ADDENDUM NO. 1
for
NORTH ROAD PAVING IMPROVEMENTS; PROJECT NO. 2019-P-5 (PHASE II)
AND
WATER MAIN PROJECT NO. 2020-W-11
CITY OF GRAND ISLAND, NEBRASKA

January 2021

The purpose of this Addendum is to:

ADDENDUM #1
AREA INLET w/ 2x2 GRATE

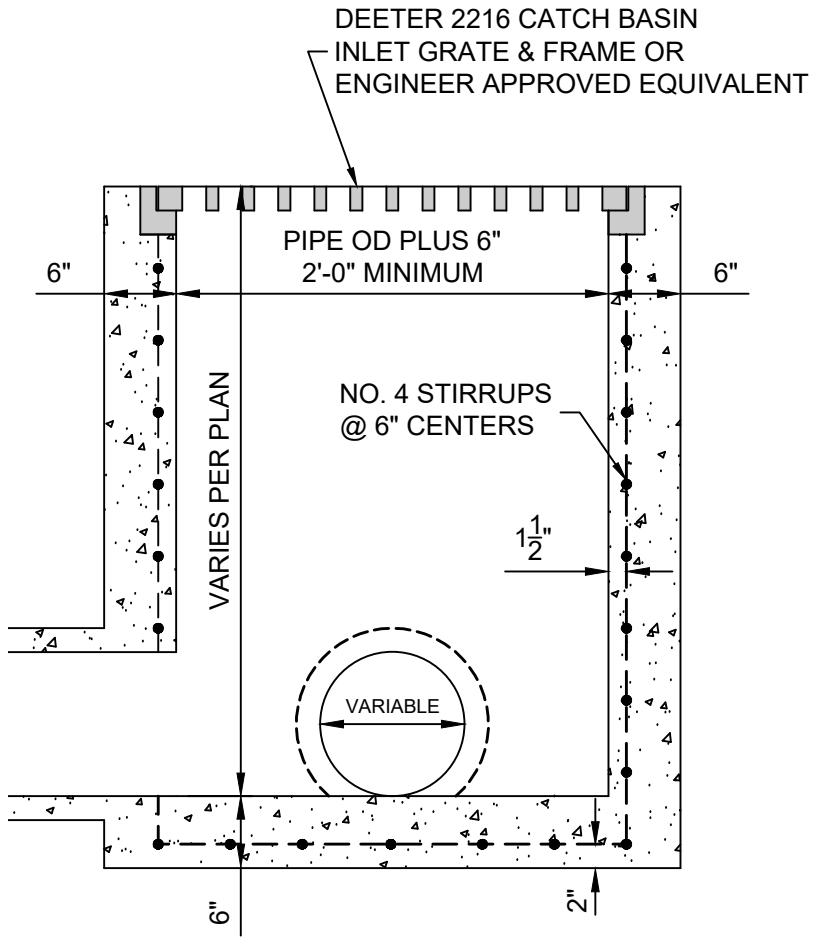
- a. Sheet C0.11 “Details”
 - i. Contractor shall Delete Detail “Section View – Area Inlet”
 - ii. Contractor shall Delete Detail “Plan View – Area Inlet”
 - iii. Contractor shall instead refer to Details attached to this Addendum #1 titled “Addendum #1 – Area Inlet w/ 2x2 Grate” and “Addendum #1 – Area Inlet w/ 3x3 Grate and w/ 4x4 Grate” for all cast in place area inlets and appropriate grates and frames. The inside box dimensions and grate and frame call-outs have been updated.
- b. Sheet C0.13 “Details”
 - i. Contractor shall Delete Detail “Headwall Section”
 - ii. Contractor shall instead refer to details attached to this Addendum #1 titled “Addendum #1 – Headwall Section”. This Headwall Section Detail shall supersede any conflicting dimensions that may be found on other details or plans sheets.

ADDENDUM #1
HEADWALL SECTION

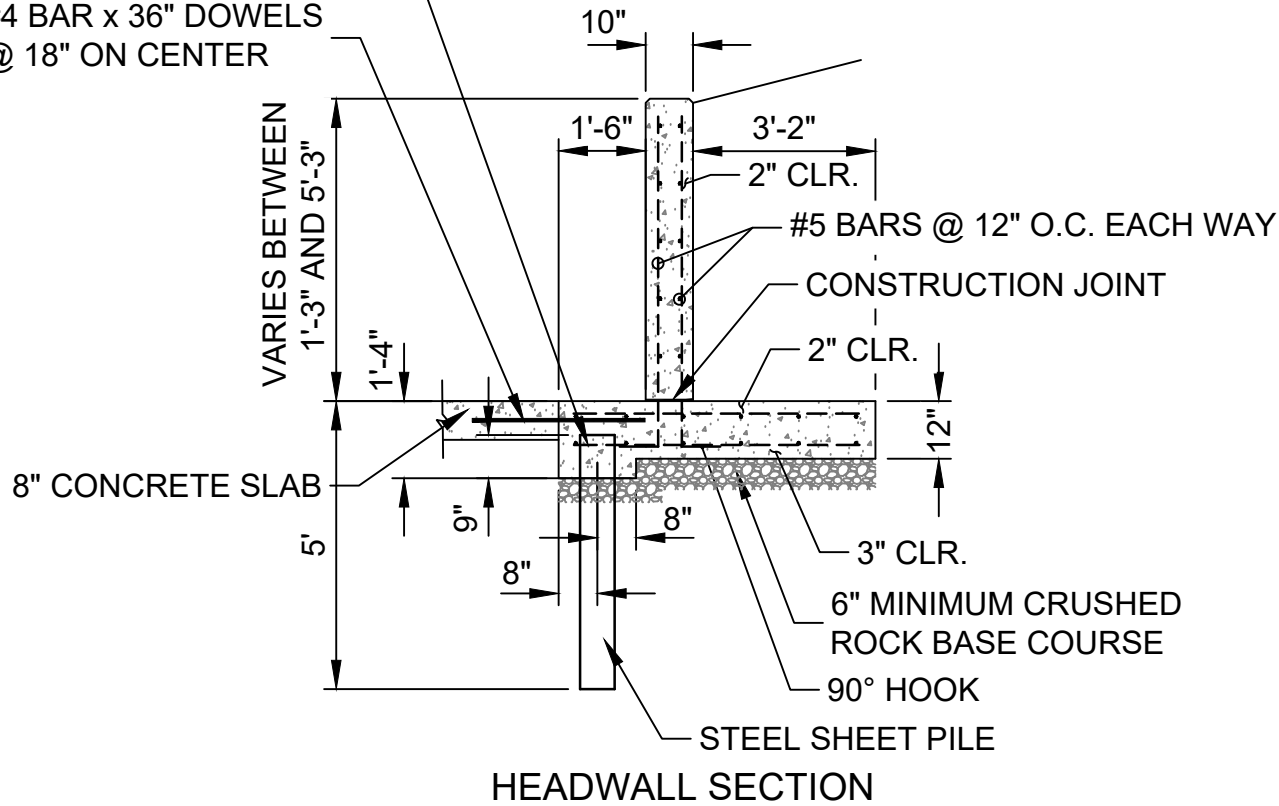
- a. Paragraph 1.10 Measurement and Payments
 - i. Delete Paragraph: B.4 Construct Concrete Headwall – Item No. 4.
 - ii. Add new Paragraph: B.4 Construct Concrete Headwall – Item No. 4 shall include all materials, backfill, soil, rock base course, concrete, reinforcing steel, sheet piling, labor excavation, backfill and compaction, hauling, loading, disposal, equipment, dewatering, grading and all subsidiary items of work for constructing Headwall, including the adjoining flume through the ditch, in accordance with the plans and specifications, specifically as shown on Sheet C5.10 at approximate Sta. 306+6.50 – 48.50' RT. The pay item is one (1) lump sum.

NOTE:
STEEL SHEET PILING SHALL BE
INTERLOCKING. STEEL SHEET PILING SHALL
HAVE A 7 GAUGE THICKNESS MINIMUM.

BURN OR DRILL HOLES THROUGH
SHEET PILE PILING TO ALLOW
PASSAGE OF REINFORCING BARS

#4 BAR x 36" DOWELS
@ 18" ON CENTER
